ITEM 4**Approval of reserved matters of CHE/20/00700/OUT for the enabling works and infrastructure across Phases 1 and 2 including details of layout, scale, external appearance, landscaping and access at Land south of Worksop Road, Mastin Moor for Devonshire Property (MM) Ltd.**

Committee Date: 21.08.2023

Informal play features:

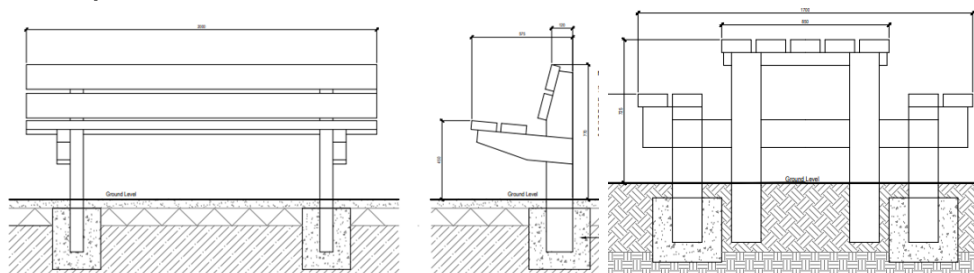
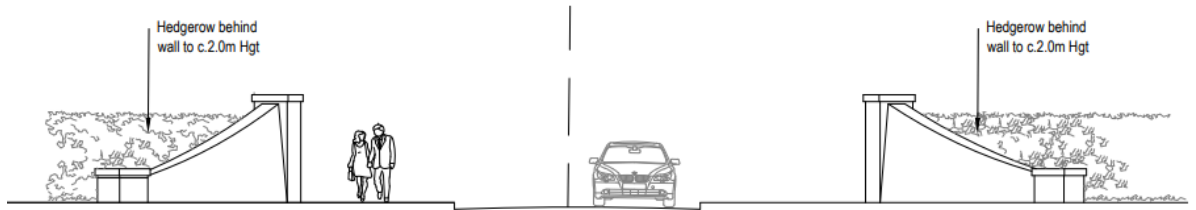
Whilst details of the informal play features such as log and boulder play elements have been provided and considered to be appropriate, details of the formal play equipment have not yet been submitted, these can be agreed via condition. Other street furniture details including signage, handrails and step design, bins, benches and bicycle stands, all of which have a similar timber theme are considered appropriate to enable the creation of a suitable open space and landscaped area to the perimeter of the site.

5. Prior to its installation details of all formal play equipment and any boundaries to the play areas shall be submitted to and agreed in writing by the Local Planning Authority. Works shall be completed in accordance with the agreed details.

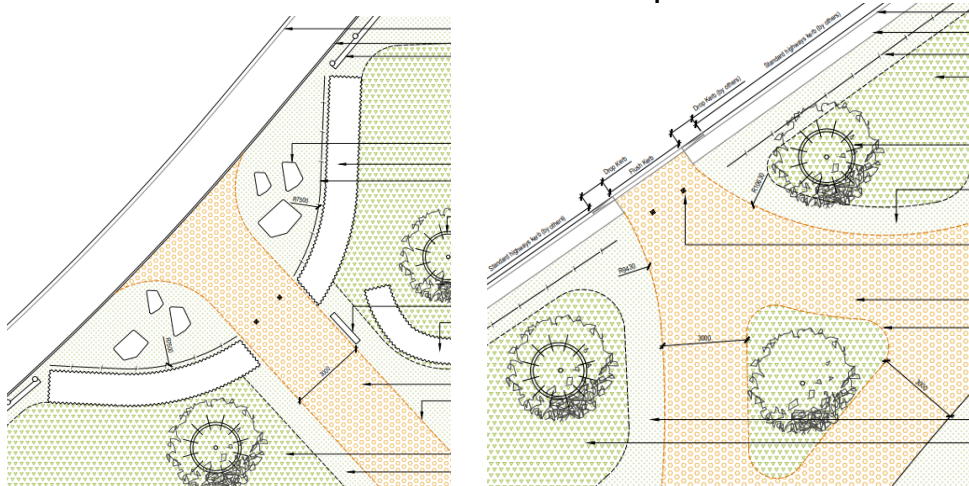
To delineate the main entrance into the site there will be a curved and sloping dry stone wall with hedge behind, this is considered to be an appropriate treatment. The selection of the walling material needs to be agreed via condition. Steel lettering of the site name is intended to be inserted into the walling:

4. Prior to works commencing on the dry-stone wall entrance feature details of the geological source of the stone shall be submitted to and agreed in writing by the Local Planning Authority. Works shall be completed in accordance with the agreed details.

Section A
Scale 1:100

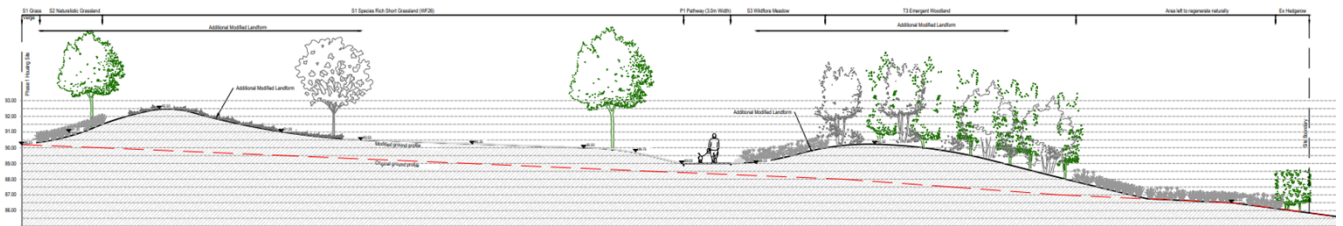
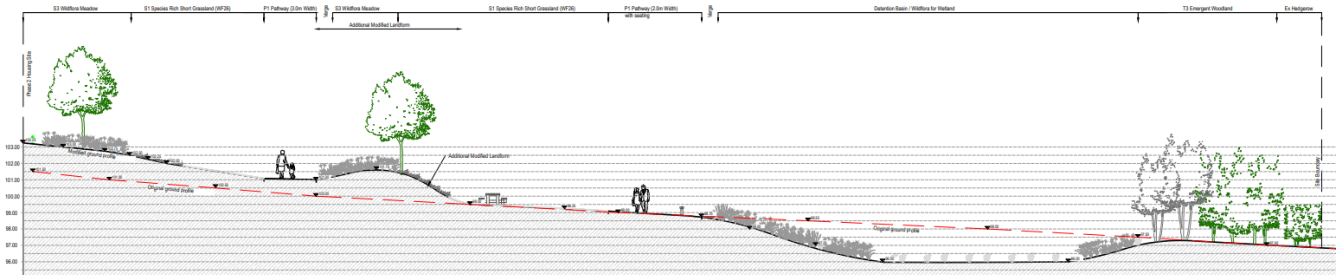
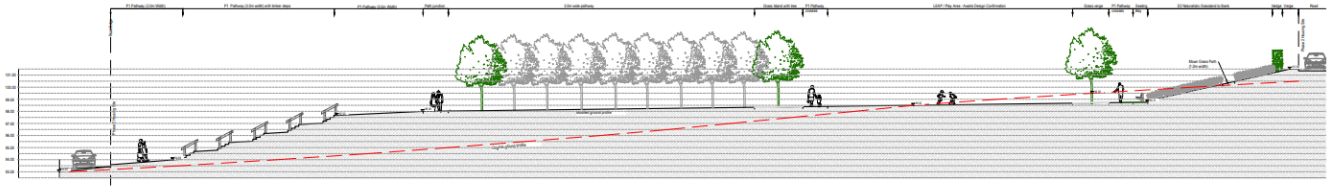
The topography of the site is relatively steeply sloping, it is intended that the development platforms for the housing will be relatively level and the land reformed to enable this, albeit these details are not provided and will be considered under the housing phases. As the slope will make steps necessary within the open space, alternative no-stepped routes are provided albeit these may be longer routes. The land inclines towards the Worksop Road and therefore the drainage ponds are intended to be to the lower slope of the land. Site sections have been provided to show how the open space will be mounded and re-formed to provide interest for routes around the site and for the pond arrangement, as set out below. These sections and the re-grading of the land in this way is considered to be appropriately considered creating an attractive area of open space. However, a section through one of the ponds in the south western corner has not been provided and therefore will be sought via condition. However, the approach provided so far is acceptable.

8. Prior to commencement, other than works to construct a temporary access and compound taking place, detailed sections through the site east west from the site boundary to the substation and to the north south from site boundary to site boundary in relation to the south western drainage pond shall be submitted to and agreed in writing by the Local Planning Authority. The development levels shall be completed in accordance with the agreed details.

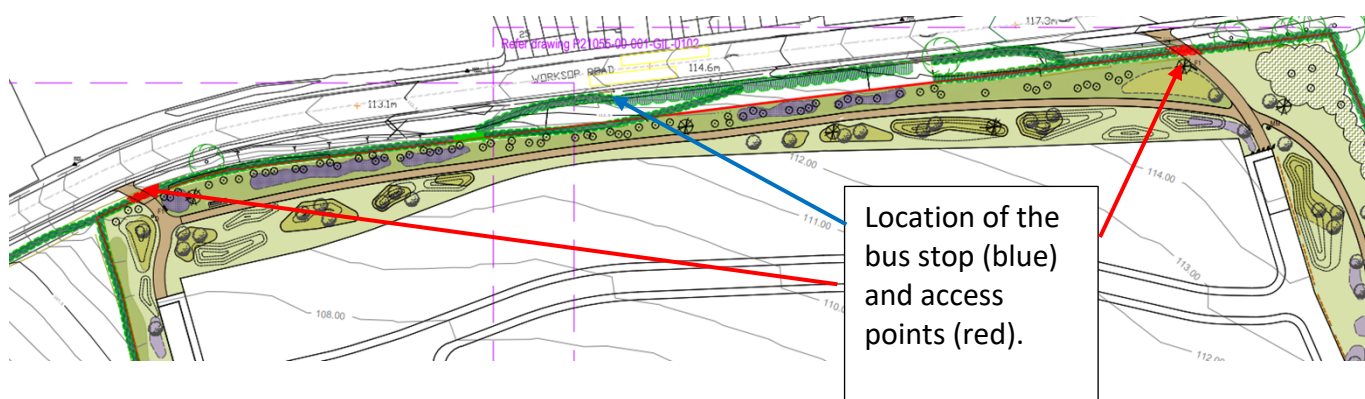
- The applicant has confirmed that self-binding gravel is proposed for the multi-user paths. This should be reconsidered as LTN 1/20 and Inclusive Mobility note that gravel surfaces can be difficult or inaccessible for people in wheelchairs and some types of adapted cycle.*

- Regarding the proposed footpath connections and their distance from the bus stop to the north of the site, the applicant has stated that this is due to third party land ownership and topographical issues. In this instance, given the size of this development, moving the bus stop to better connect with the footpath connections should be considered. As public transport has a strong link with active travel, and the TA in the outline application was clear that it had been designed to promote accessibility to public transport, pedestrian and cycle movements, Active Travel England would expect access to the bus stop to be made more convenient rather than involve an indirect walk, finishing on a narrow pavement alongside a busy A road with traffic speeds in excess of what would be considered comfortable or safe in an urban setting.*

- *The applicants' response regarding bollard spacing and Inclusive Mobility requirements is noted, however, given that the path in question is intended to serve multiple different types of user including cyclists (according to the TA submitted with the outline proposal) ATE would request that LTN 1/20 is the more appropriate guidance in this instance. The paths in question would appear well overlooked, which is welcomed and will also decrease the likelihood of misuse by motorised vehicles.*

- 5.8.11 The use of self binding gravel is generally considered an appropriate surface for all users of paths and cycle ways. The concerns note the requirements of LTN 1/20, this document specifically refers to loose gravel being inappropriate, however that is not what is proposed in this case. Self-binding gravel as proposed does provide a solid surface and its use is not contrary to advice within LTN1/20. The Outdoor Accessibility Guidance which supports inclusive outdoor access notes that the use of self binding gravel provides a firm and stable surface if well constructed. It is the case that if water logged or with over use it may require more regular maintenance, but this is the responsibility of the applicant in this case who is choosing to use this surface. In addition, it is worth noting that the constructional detail for this includes a camber which should avoid water collection. Therefore, it is considered that the proposed surface is acceptable.

- 5.8.12 In terms of the connection to the bus stop, the links the public highway at the east and west of the northern boundary are considered to be appropriate desire lines as shown below:

The intention is to link to the bus stop and to the local centre to the west. Whilst the links are remote from the bus stop it is not considered that this is inappropriate in this case. The land between the bus stop and the site edge is within third party ownership and therefore the applicant has no right to cross this. In addition, if the link was provided further towards the bus stop it would not necessarily be a better route given the road access points are to the eastern and western edges therefore this is the best direction for most of the future residents. Whilst the relocation of the bus stop has been suggested, this was not accounted for in the contributions at the outline stage and it is noted that due to the topography, alignment and restrictions on the road in this location moving the bus stop to the west would be unlikely to be practical. On this basis the links to the east and west are considered appropriate.
